ADDENDUM NO. 03

Perry Township Schools – Innovation & Entrepreneurship Center
3949 South State Ave
Indianapolis, IN 46227

ADDENDUM NO. 03

PROJECT:	**PERRY TOWNSHIP SCHOOLS** **New Innovation & Entrepreneurship Center**
PROJECT NUMBER:	**25150**
DATE OF ADDENDUM:	**November 11, 2026**

SANITARY REROUTE
PLAN AND PLAN AND PROFILE

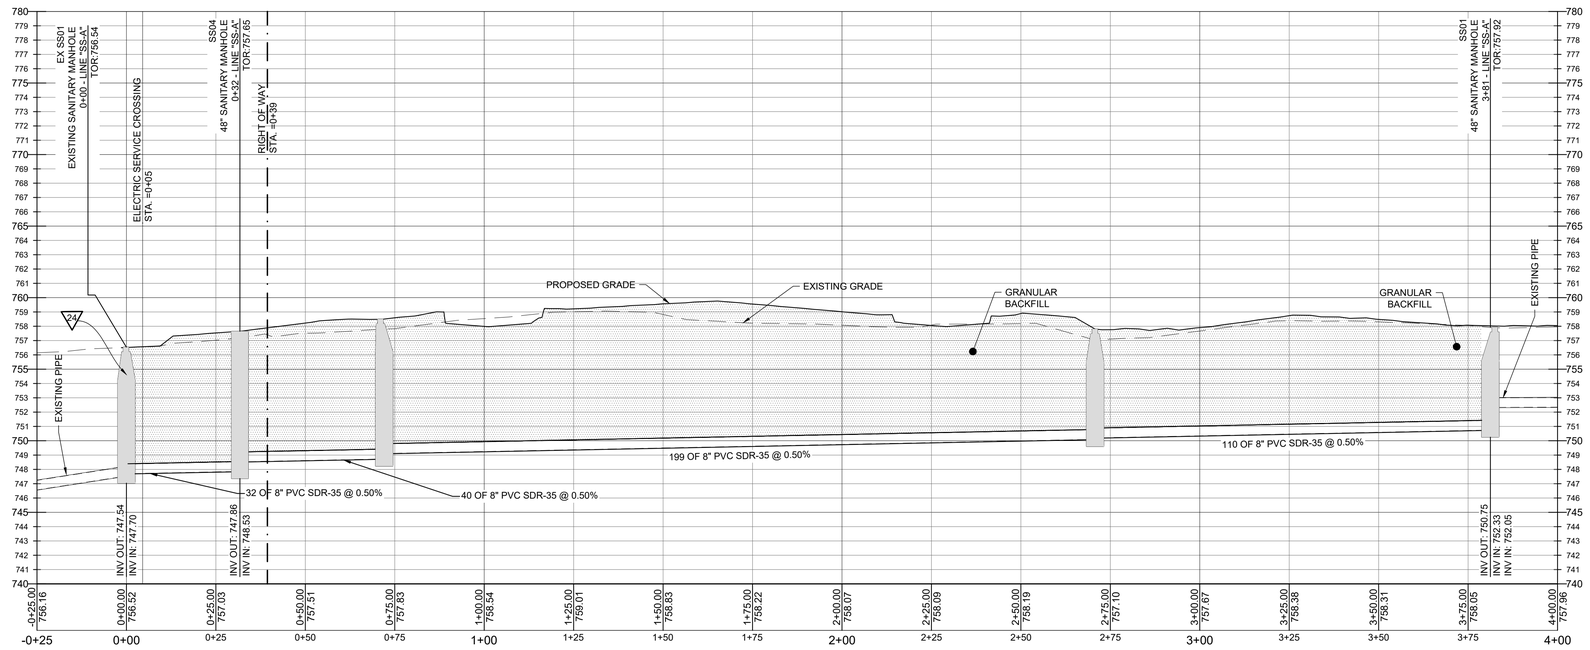
Change: Updated Sanitary Structure Data Table per CEG review.

INTERIOR FINISH PLAN - SECOND FLOOR

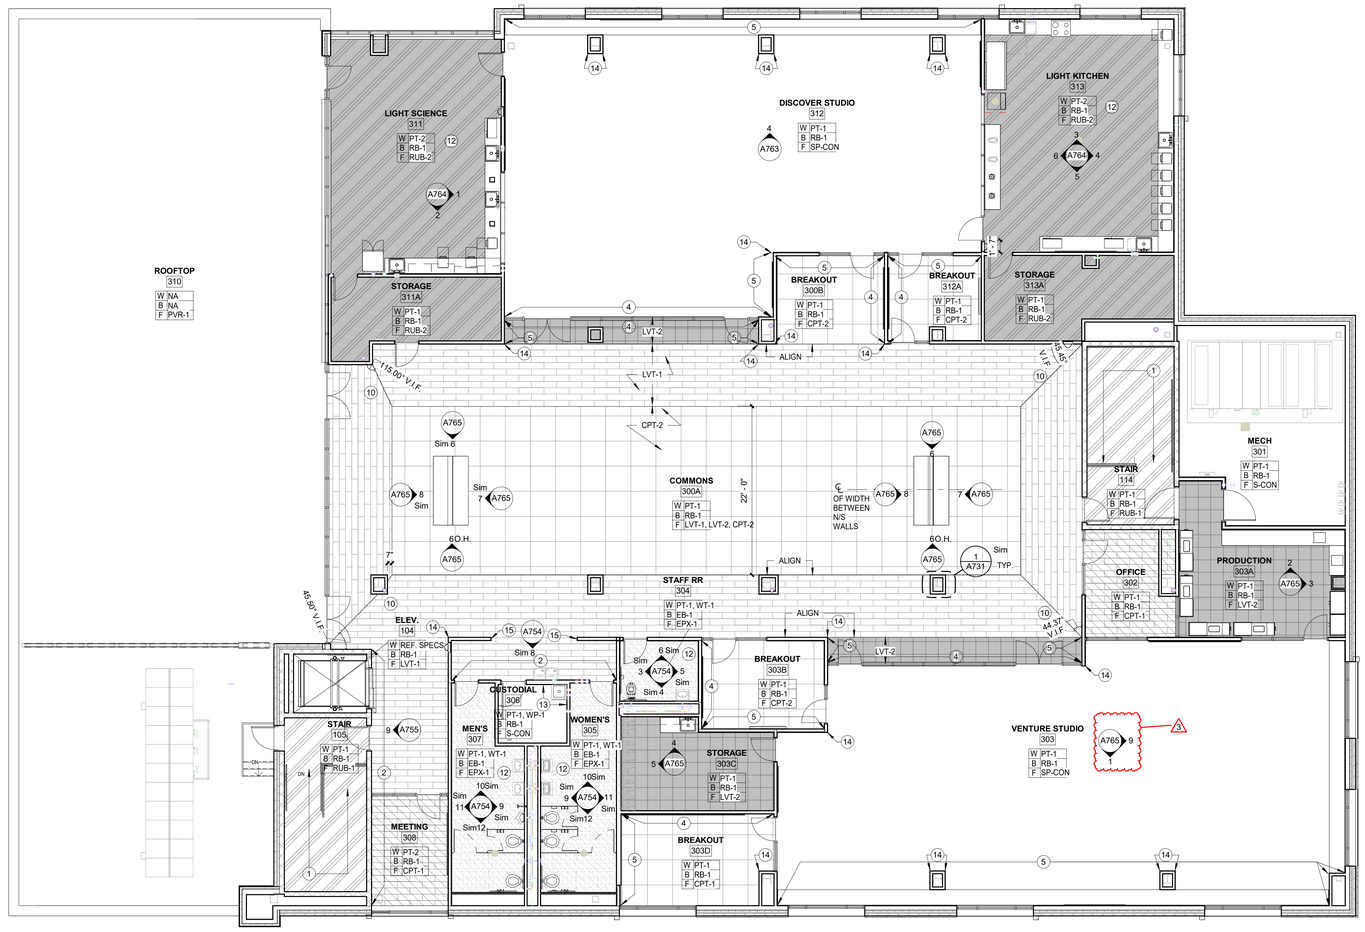
20. **Question:** AWP-1 Acoustic Foam Wall Panels – Podcast Studio 201G, Music Studio 201I and Control 201H (A720 / A722): The Finish Plan (A722) tags the walls in Rooms 201G and 201I as “PT-4, AWP-1,” but no interior elevations are provided for these rooms. Please confirm whether all walls are to be fully covered with AWP-1, or only portions of the walls. If only portions are to be covered, please provide interior elevations showing extent, mounting height, and layout. Additionally: The Finish Legend lists “Control” as an AWP-1 location, but the finish tag for Control 201H does not include AWP-1. Please confirm whether AWP-1 is required in Room 201H.

Change: Acoustical Wall Panel AWP-1 has been added in the Music Studio, with clarifying note 16 added to the plan notes. New instances of keynote 14 have been added to the west side of Commons 200A.

Response: Podcast Studio 201G walls are to be fully covered with AWP-1. No AWP-1 is required in Control Room 201H. The only room with portions of the walls to be covered with AWP-1 is Music Studio 201I. See updated attached sheets A722 and A754.

INTERIOR FINISH PLAN - THIRD FLOOR

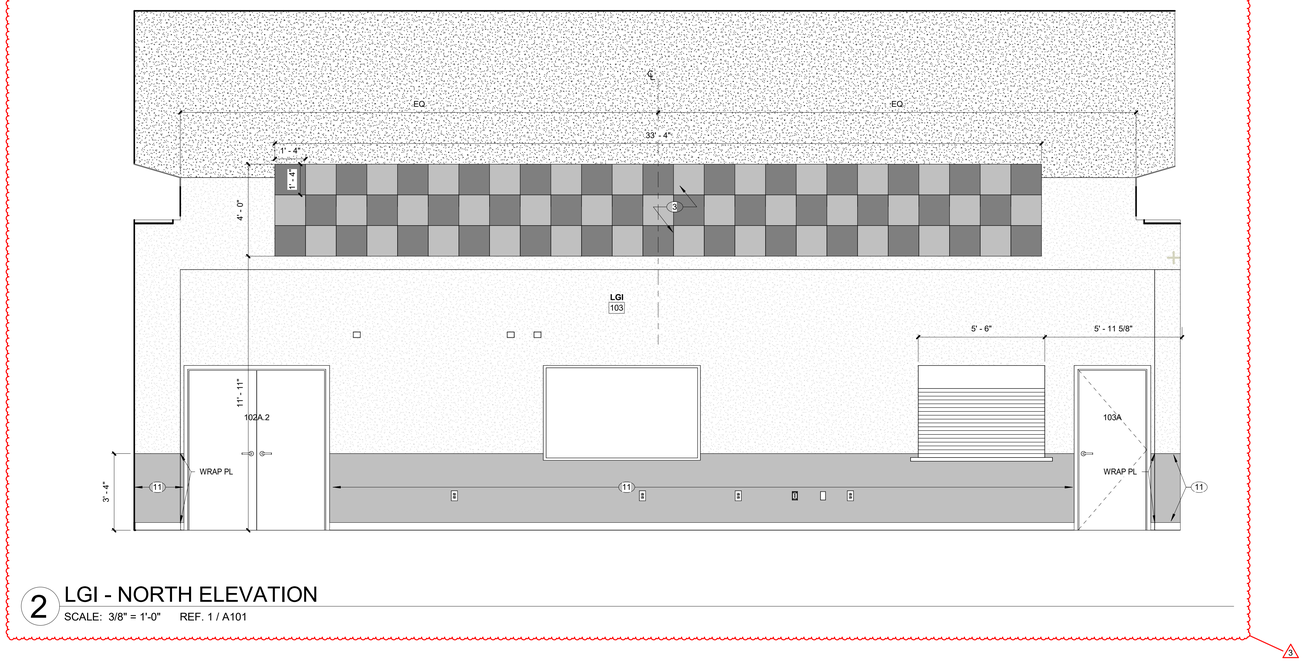
Change: Casework elevation 9/A765 has been added to the Venture Studio 303.

2 LGI - NORTH ELEVATION

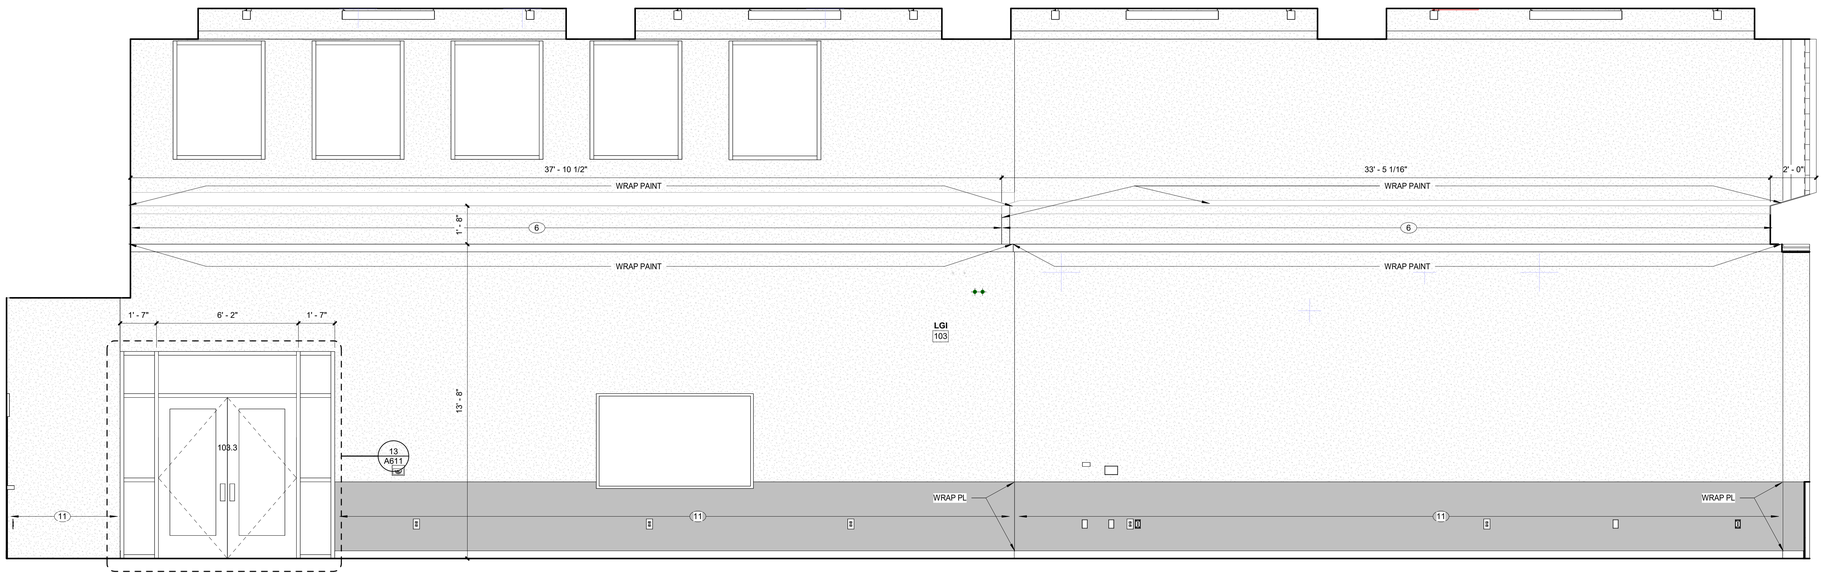
4. **Question:** In LGI, Room 103, there are PL-2 laminate wall panels on the walls depicted by Elevation Note 11. These panels terminate about 40 from the floor with painted walls above. Interior Elevation 2/A751 has the gray color continuing above the 40" height, but Elevation Note 11 is only shown at the 40" height. Are we to include laminate wall panels above the 40" height?

Change: Extents of plastic laminate paneling have been revised in 2/A751 LGI – NORTH ELEVATION.

Response: Do not continue laminate wall panels above 40" height. Elevation 2/A751 has been revised. Please refer to the attached revised A751 INTERIOR ELEVATIONS sheet.

13 INT. ELEV. - TYP. MUSIC STUDIO WALLS
SCALE: 3/8" = 1'-0" REF. 1 / A102

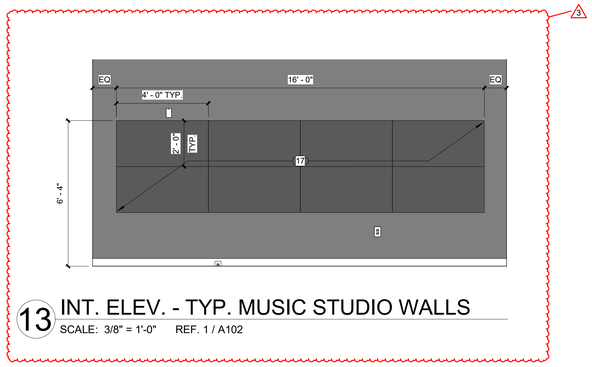
Change: Elevation 13 has been added to clarify extents of AWP-1 in the Music Room

Change: Elevation Keynote 17 has been added to callout AWP-1.

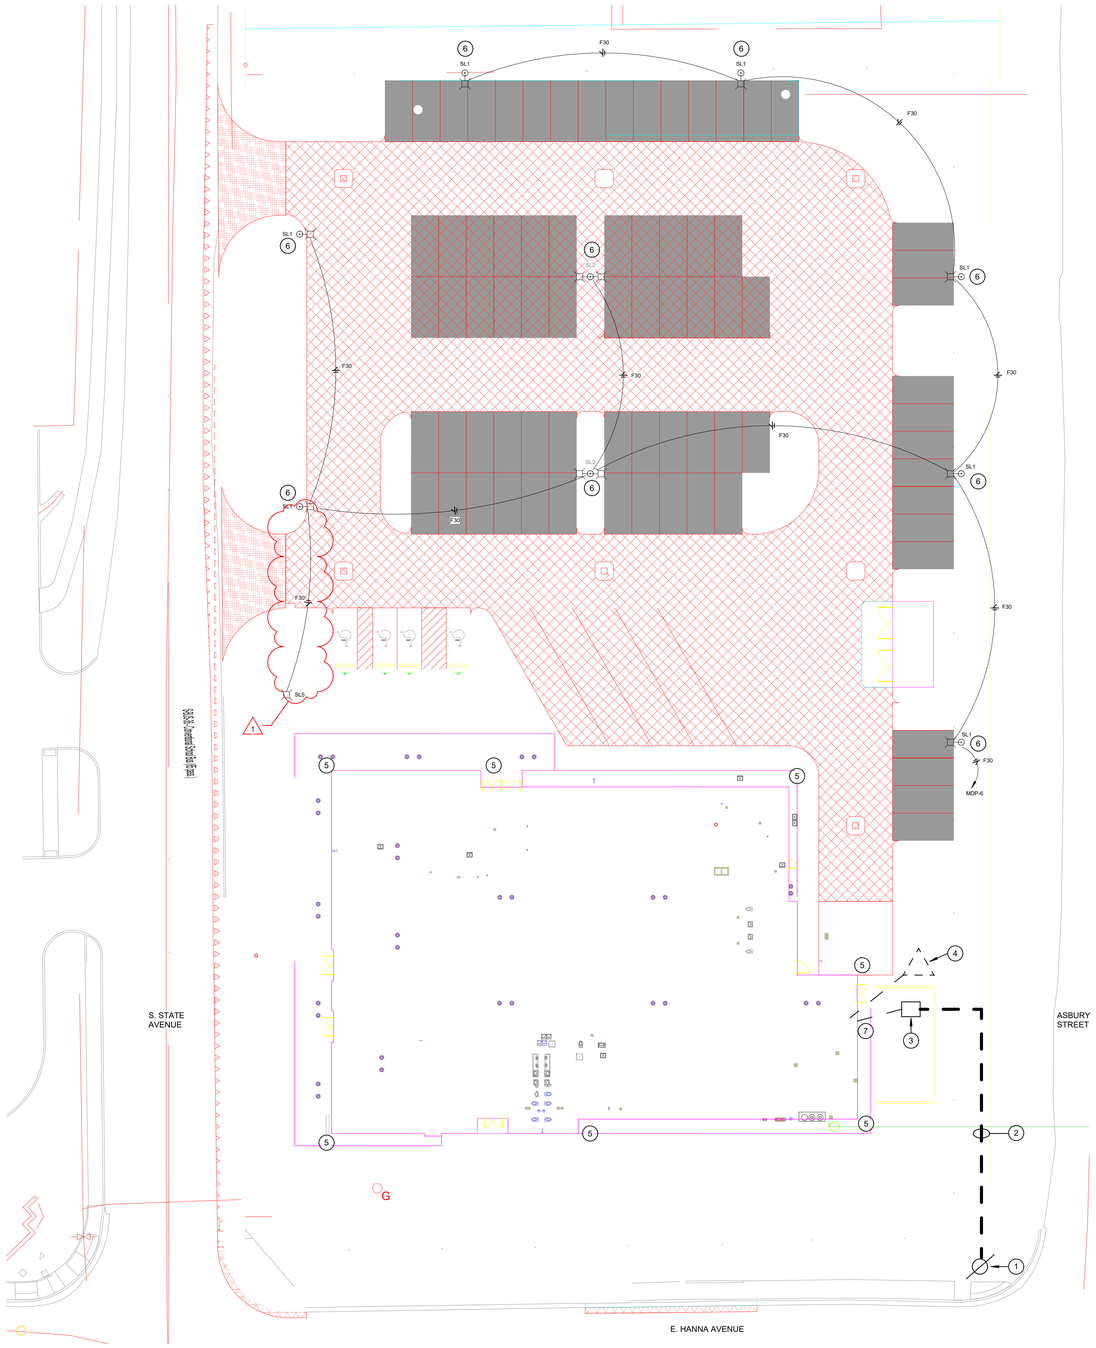
2. **Question:** There appears to be casework on the east wall of Room 303, if so please provide casework elevations for this.

Change: Elevation 9 has been added to show east wall of casework in Venture Studio 303.

Response: Correct. An elevation has been provided. Please refer to the attached revised A765 CASEWORK ELEVATIONS sheet.
